ADA Curb Ramp New Construction Inspection Form (Perpendicular)

Ramp Style **PR**

PERPENDICULAR RAMP (PR)

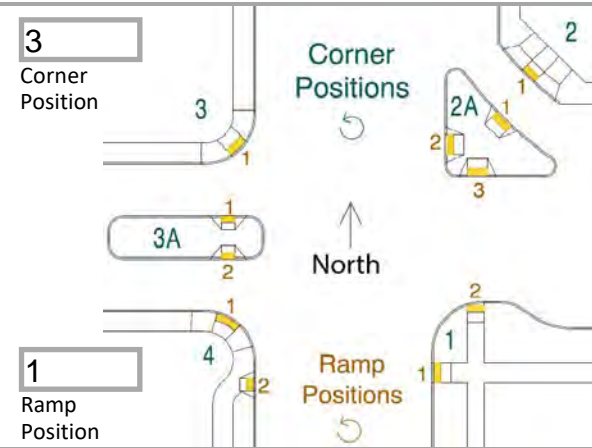
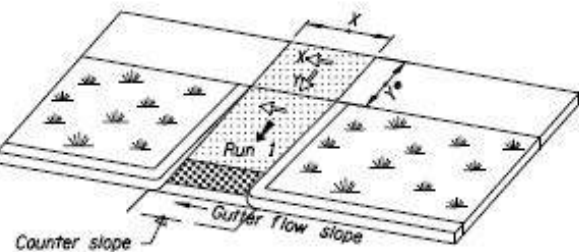
5.9

CS FAIL NORTH END
